**SPRING HILL PLANNING COMMISSION
REGULAR MEETING
AGENDA
THURSDAY, MARCH 3, 2016
7:00 P.M.
SPRING HILL CIVIC CENTER
401 N. MADISON – ROOM 15**

1. **Approval of Minutes: February 4, 2016**
2. **Site Plan (SP-01-16) – Mid Am Building Supply Site Improvements**
Address/Vicinity: 20301 W. 207th St.
Applicant: Mid Am Building Supply
3. **Preliminary Plat Extension Request (PP-01-16) – Ridgefield Subdivision**
Address/Vicinity: 16915 & 17505 W. 199th St. (west of Renner Rd.)
Applicant: Renner 199 Investors, LLC
4. **Public Hearing – Proposed Amendments to the Zoning, Subdivision, and Sign Regulations**
5. **Establish an alternate date for the April 2016 Planning Commission meeting**

BACKGROUND: The applicant, Mid-Am Building Supply, has submitted a request for approval of a site development plan at 20301 W. 207th St. The project consists of a stormwater detention basin with connecting piping, private access road, gravel outside storage area, fencing, lighting and landscaping.

SITE DEVELOPMENT PLAN MID AM BUILDING SUPPLY SECTION 14, TOWNSHIP 15 SOUTH, RANGE 23 EAST CITY OF SPRING HILL, JOHNSON COUNTY, KANSAS

Cover Sheet

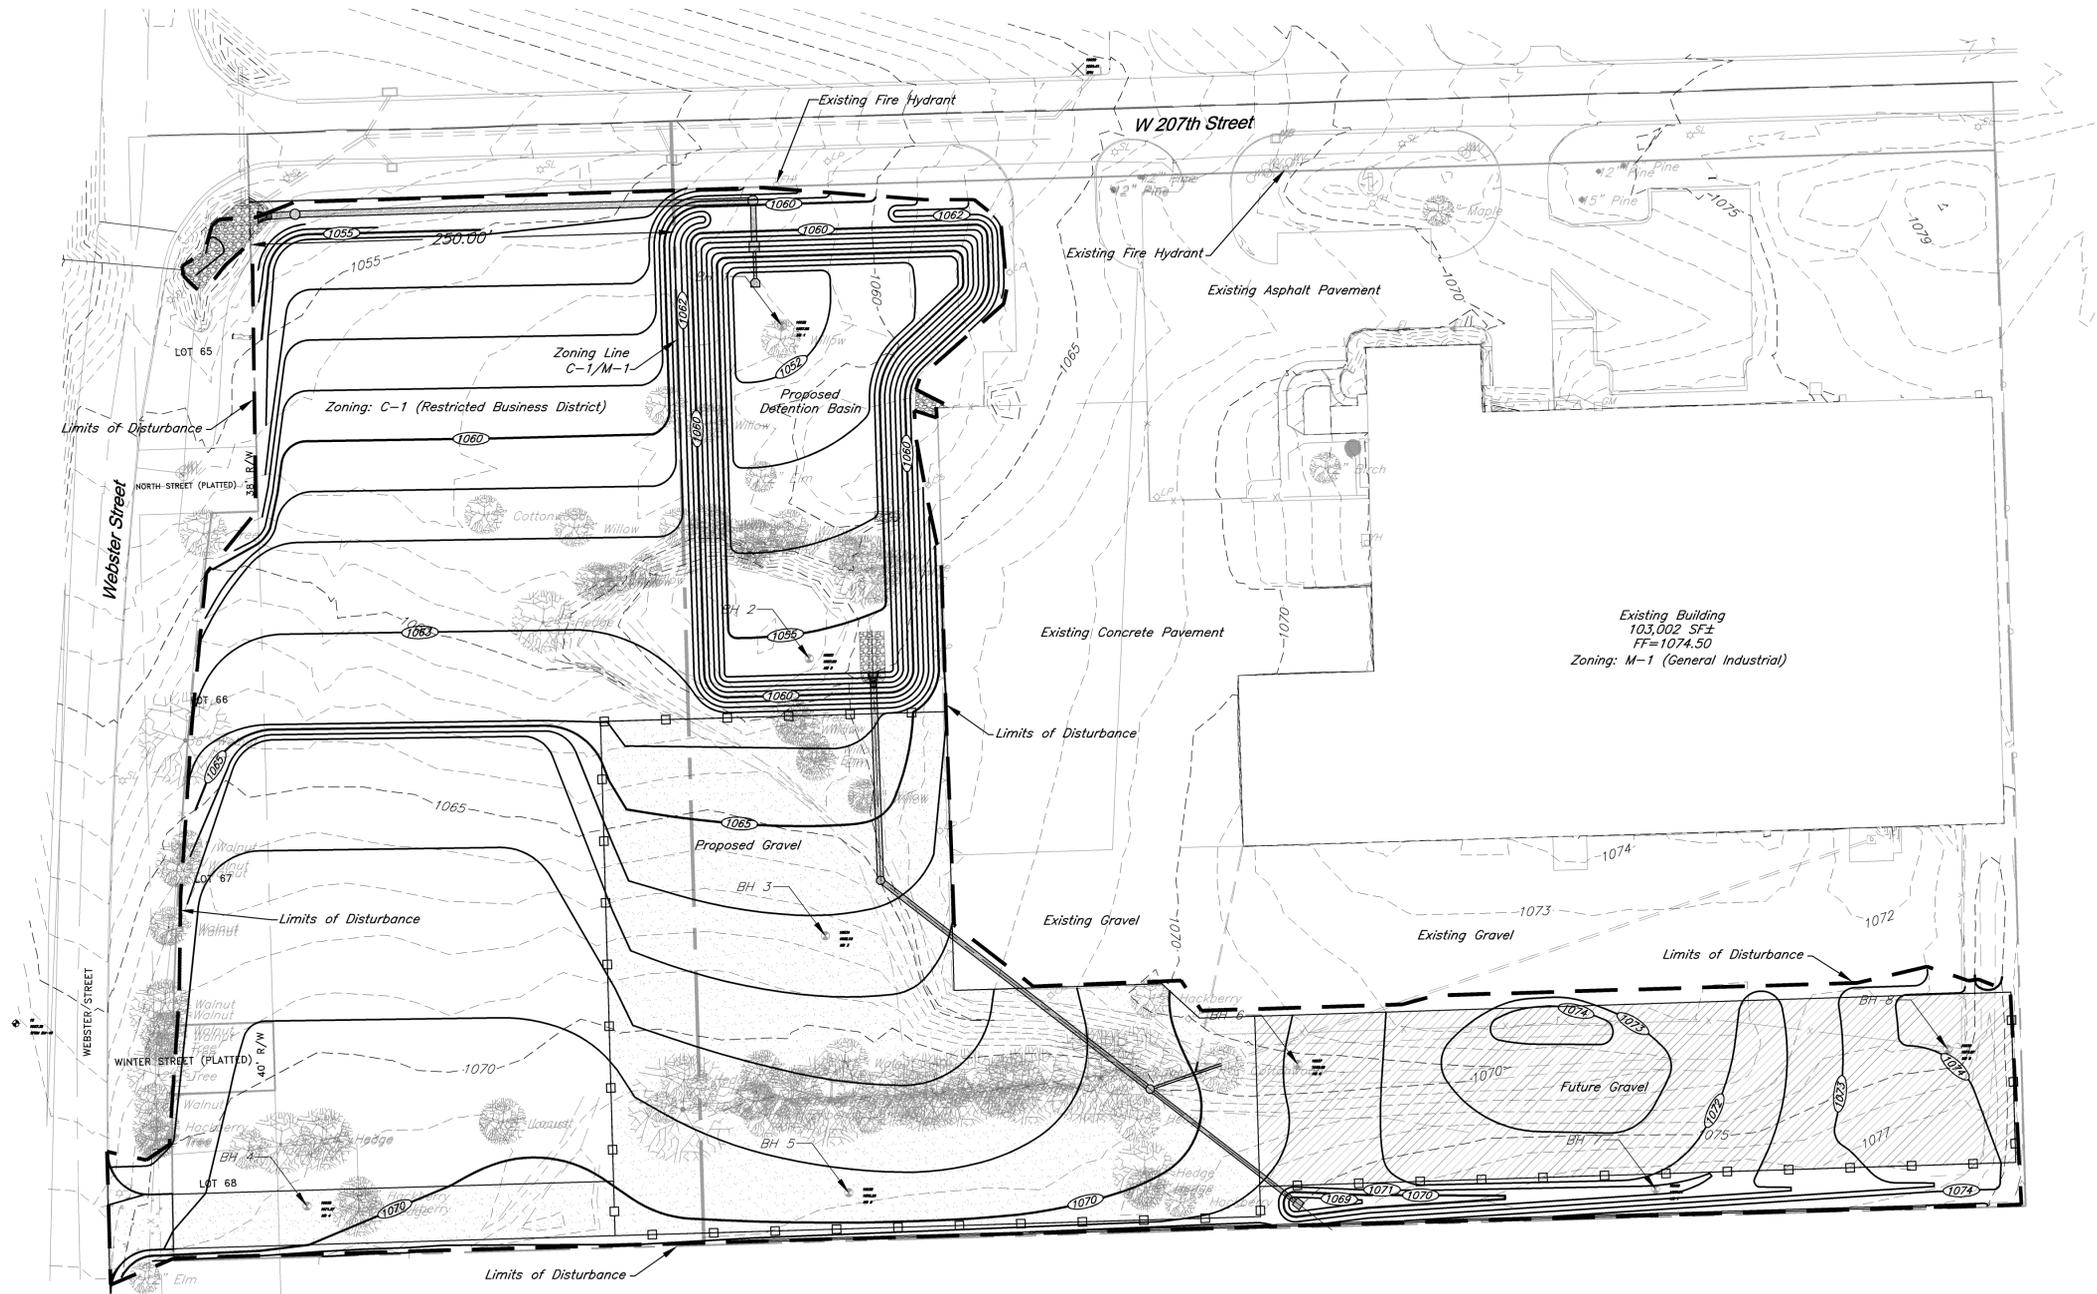
1. Sheet C1 – Need to add a signature block and date for “Acting Director of Public Works”
GBA Response: Signature Block added.
2. Sheet C2 – At the southeast corner of Webster and 207th, there are two additional existing storm sewer lines that are not shown. One is a 30” RCP under 207th flowing from the north side of 207th to the south side. There is also a 36” RCP flowing from the existing westerly most junction box (shown on the drawing in the middle of 207th Street) southwesterly to the existing ditch on the south side of 207th Street. Because there are already 2 pipes discharging to this existing ditch, may want to consider adding another junction box to combine the existing 36” RCP with the proposed new 42” RCP before discharging to the ditch.
GBA Response: The two pipes near the SE corner of 207th and Webster have been located and shown on the plans. The existing pipes and the alignment of the proposed pipe do not allow for a junction box to be easily placed connecting all pipes. To ensure erosion control and drainage in the area, the area between the existing pipes and RCB is to be regraded and lined with rip rap.

Utility Plan

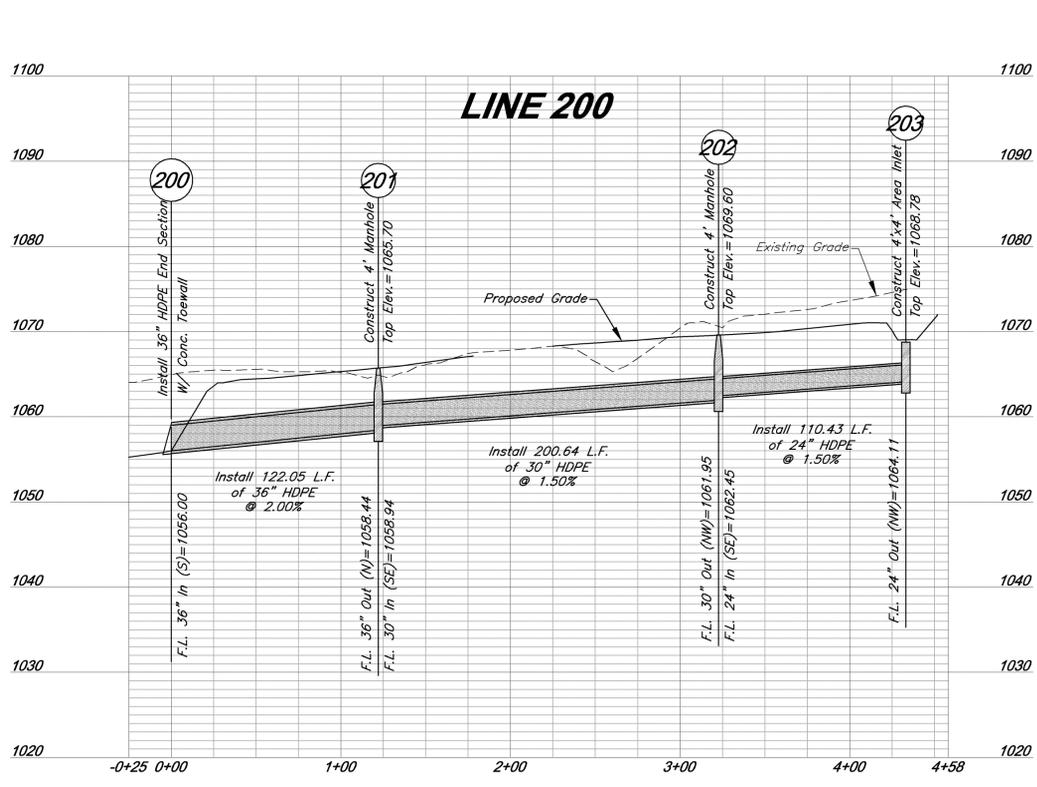
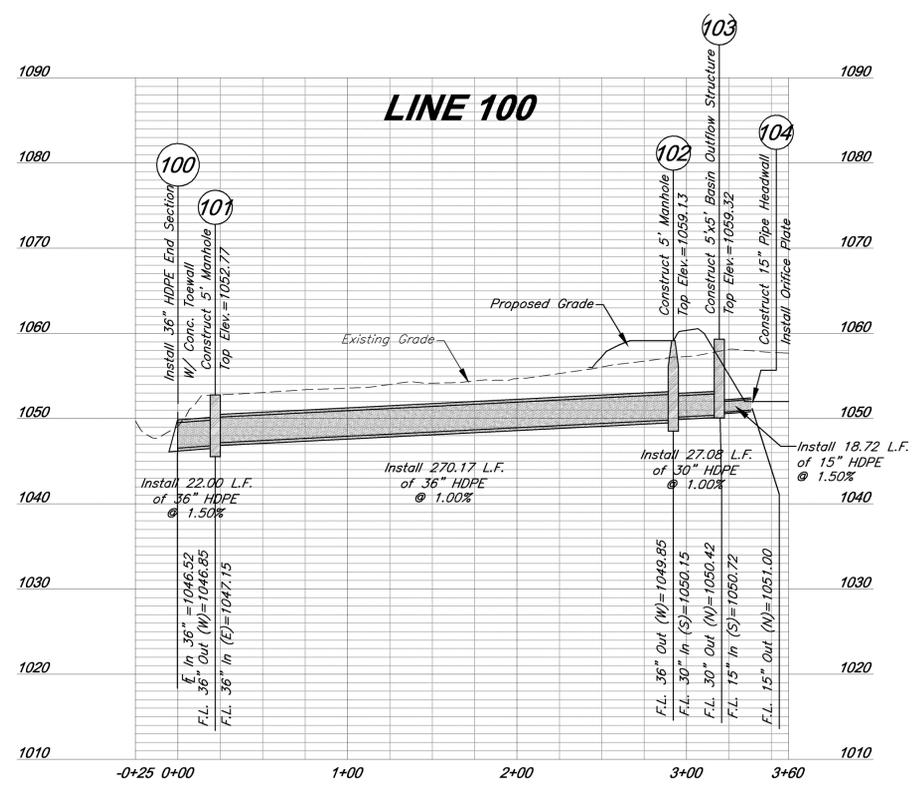
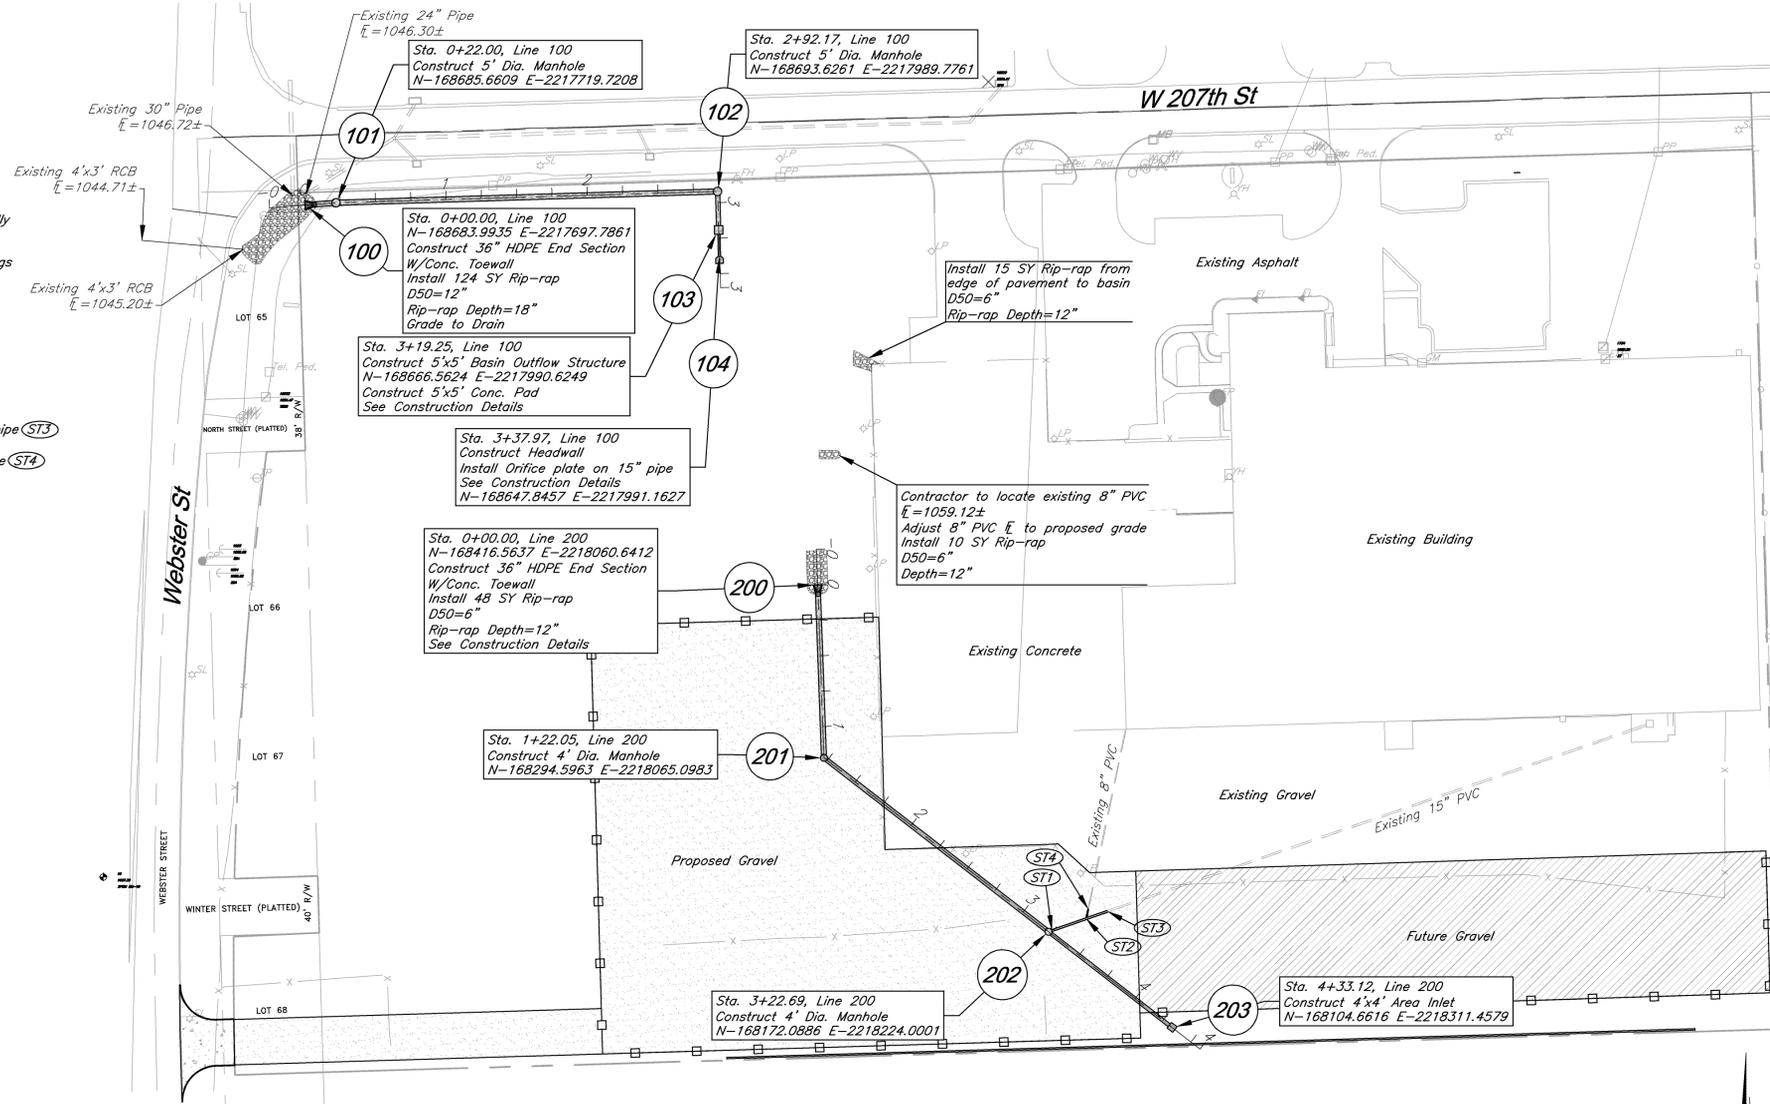
3. Stormwater Lines – The calculated hydraulic grade line of 1059.19 at structure 103 is above the calculated 100-year elevation of the detention basin. The capacity of the pipes and the interaction with the detention basin should be reviewed to assure that the downstream pipes are not limiting outflow from the detention basin. **GBA Response:** The detention basin outflow structure and pipes have been adjusted to change peak outflows and the hydraulic grade.
